January 18, 2018

**Response to Data Request and Comments
Hydrogeological Reevaluation Report
East Swedesford Road and Horizontal Directional Drill (S3-0381)
DEP Permit No. E 15-862
West Whiteland Township, Chester County, PA**

SUNOCO
E LINCOLN WAY/US BUS HWY 30/S.R. 3070
WEST WHITELAND TOWNSHIP, CHESTER CO., PA

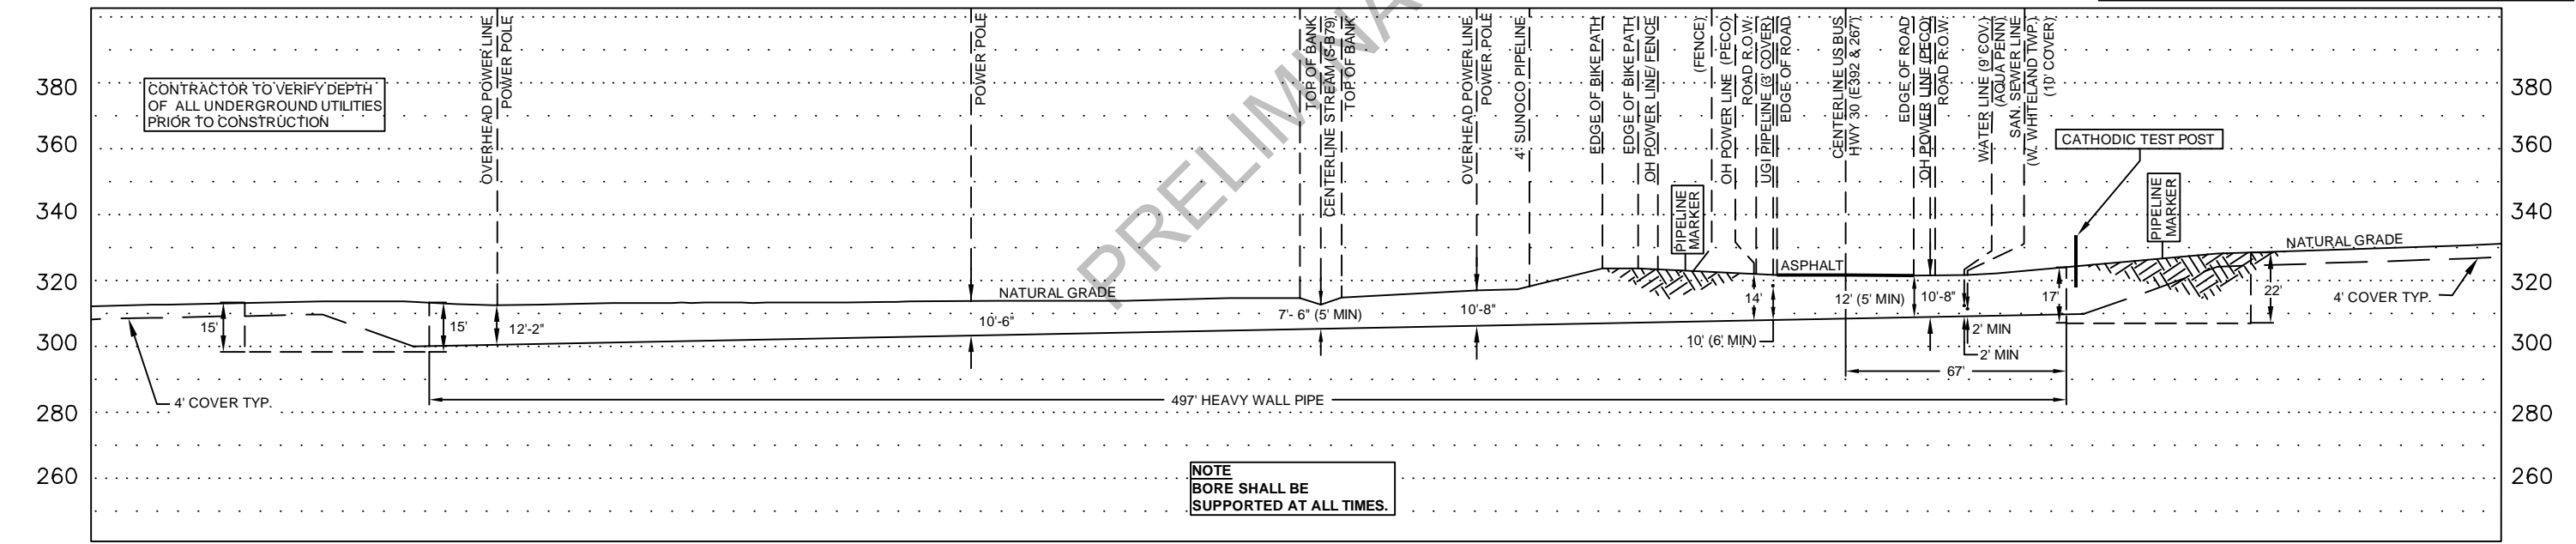
e. Provide a specific detail on how the “flex bore” unit will be set up at the entry/exit points, including any necessary bore or “relief” pits.

As you will see upon review of the attached revised plans, the installation plans no longer follow a profile or subsurface radius representative of an HDD, but rather is a straight pit launched bore approximately 497 ft in length, with a minimum depth of cover of 7 foot (ft), and maximum depth of cover of 17 ft. The entire length of this bore would pass through overburden materials.

The revised plan of installation attached to this response indicates the location and size of the pits that will be utilized during the bore. A plan view and cross section typical for a FlexBor is attached to show the arrangement of equipment. No relief pits are planned, nor should any be required.
